Tom Renzo proposed the following features for Cave 2. In both images, you are looking south toward Cave 1

We came up with the following questions/comments:

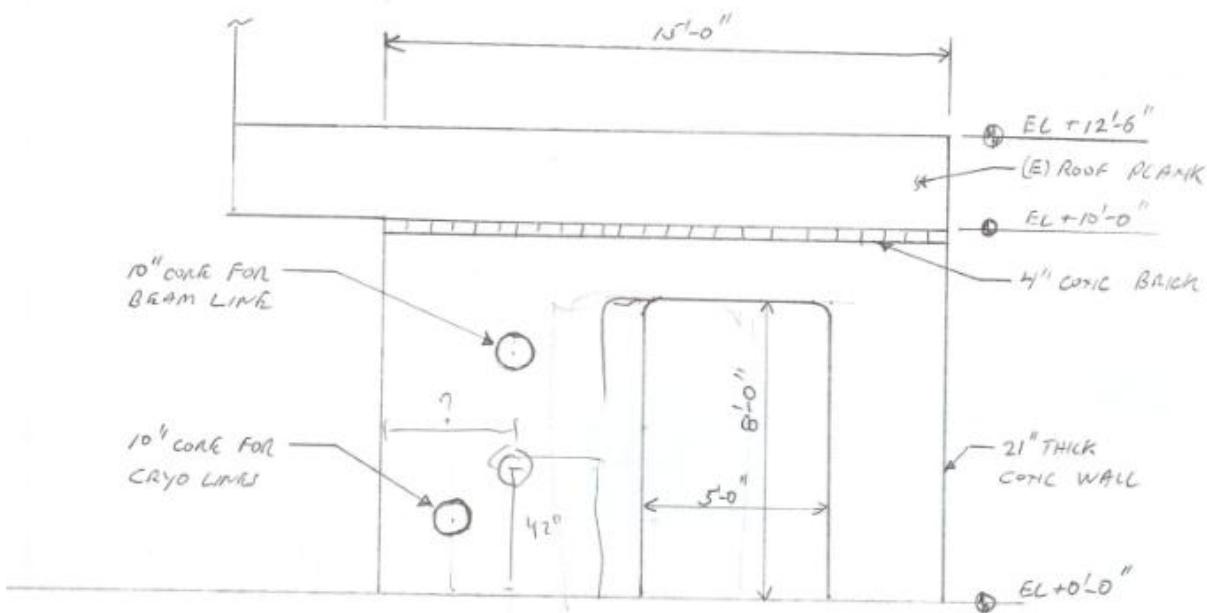
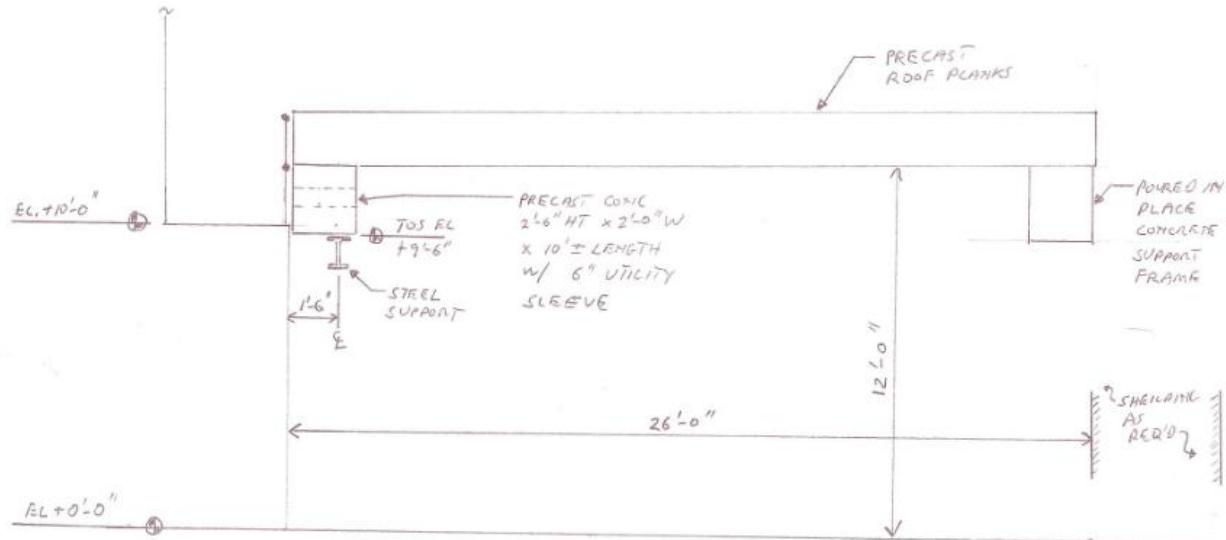
- 1) How long will Cave 2 be? Answer: as long as possible. The outside wall of the North side of Cave 2 should line up with the existing yellow walkway. And per Rad Con's calculations, we assume the North wall is 6 ft thick.

- 2) Tom suggested an opening between the two caves 5 ft wide and 8 ft tall. We suggested 6 ft wide. But a wider opening might diminish structural integrity of this wall. Either way, we should be able to move the 1/4CM through this opening.

- 3) How far OFF the wall does HDIce live? Our plans today imagine the beamline approximately 50inches displaced from the East wall. We think HDIce is approximately 4 ft wide, and centered on the beamline, so HDIce would extend 2 ft on either side of beamline. Consequently, this seems compatible with our 50 inch beamline displacement from wall. We won't need to introduce a "jog" or bend in the beamline. Viewed from above, the beamline will be straight. We will likely want to coordinate the placement of steel I-beams that will hold up the ceiling. I-beams every 18 to 24 inches, to maximize available space to work on HDIce.

- 4) HDIce will be approximately 8 ft in air, so Cave 2 with 12 ft ceiling seems fine.
- 5) How many core holes do we need in the wall between caves? One for beamline, and one for cryo plumbing. Do we need holes for LCW and our beamline cables? 10 inches diameter ok?

- 6) Roots blower inside Cave1 or outside? Pros and cons to both. Today, we are planning on leaving blower inside Cave1, and dealing with noise and heat the blowers produce.
